BAYOU DUPRE
CONTROL STRUCTURE

PERIODIC INSPECTION REPORT NO. 2

SUBJECT: Lake Pontchartrain, Louisiana and Vicinity, Chalmette Area Plan;
Bayou Dupre Control Structure, Periodic Inspection Report No. 2,
Mar 1980

1. The inclosed periodic inspection report is approved subject to the following comments:

CLOSURE DAM AND LEVEE PLAN, PROFILE

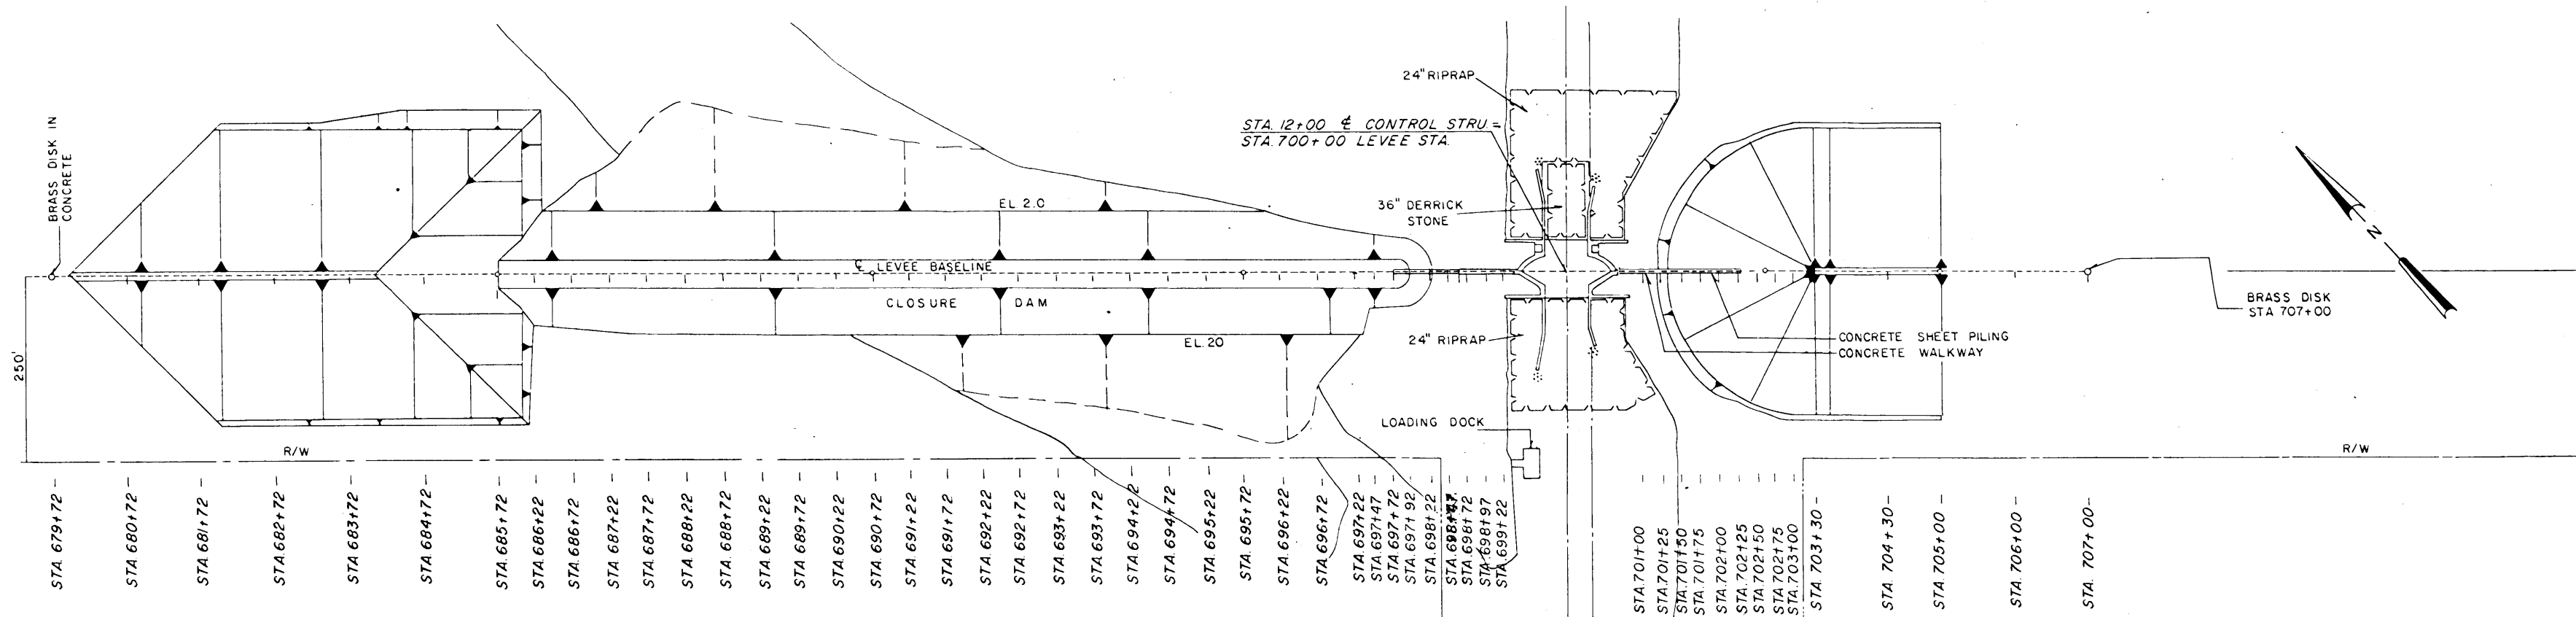
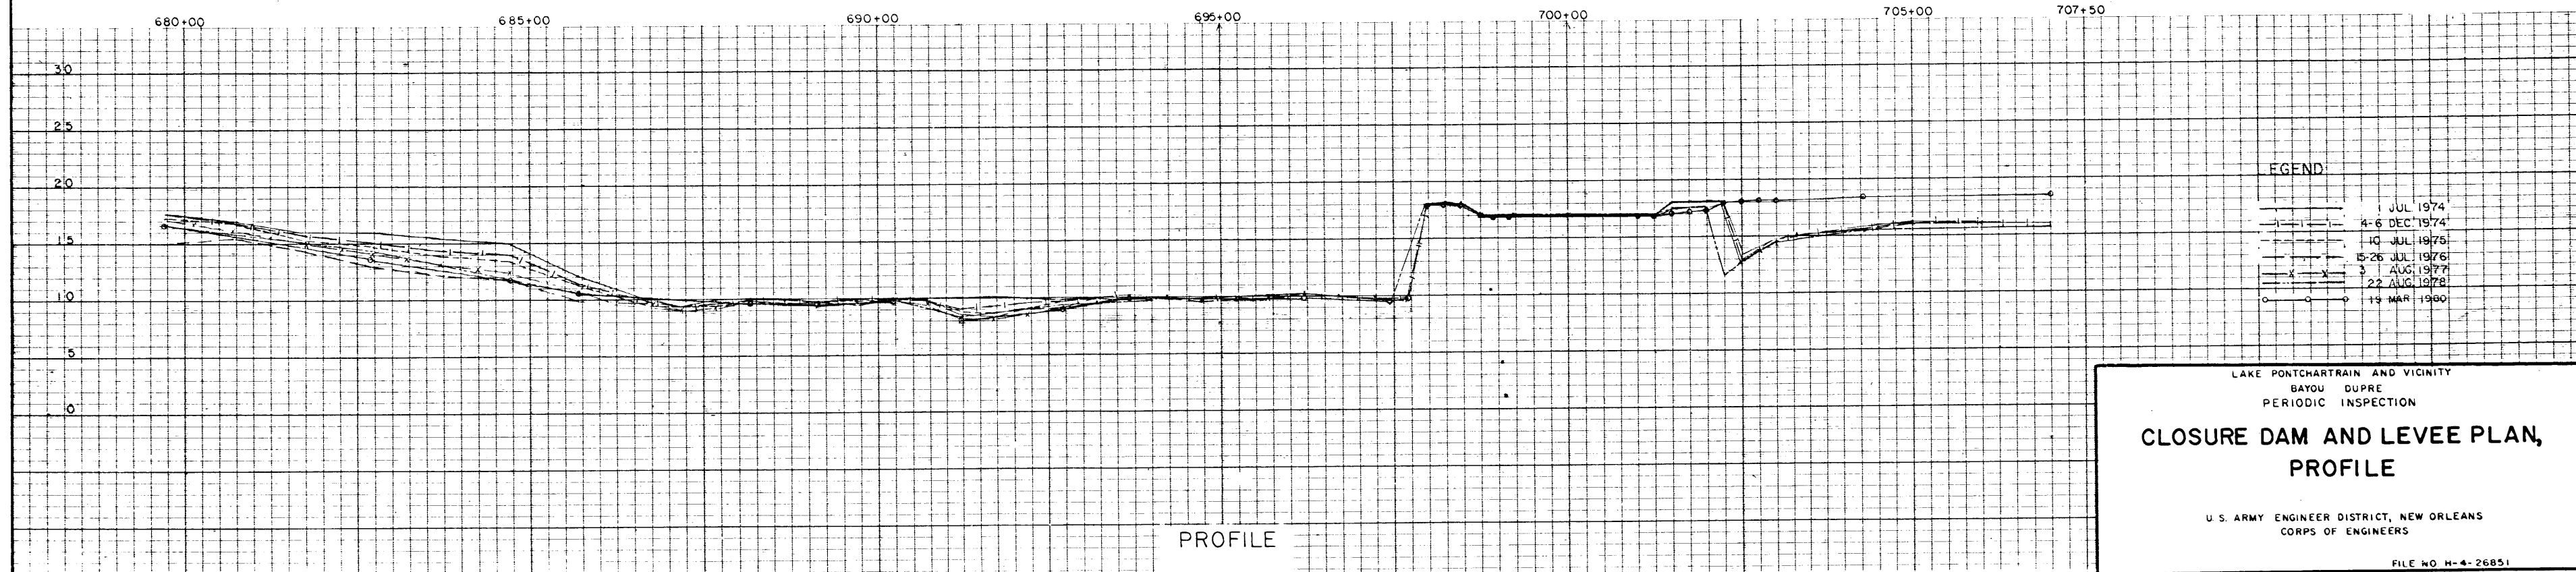
(2) Settlement of the closure dam and levees as indicated by the data on the Closure Dam and Levee Plan-Profile on Plate 9 should also be discussed in para 4-03a.

(2) A discussion of the settlement of the Closure Dam and Levee has been included in paragraph 4-03a.
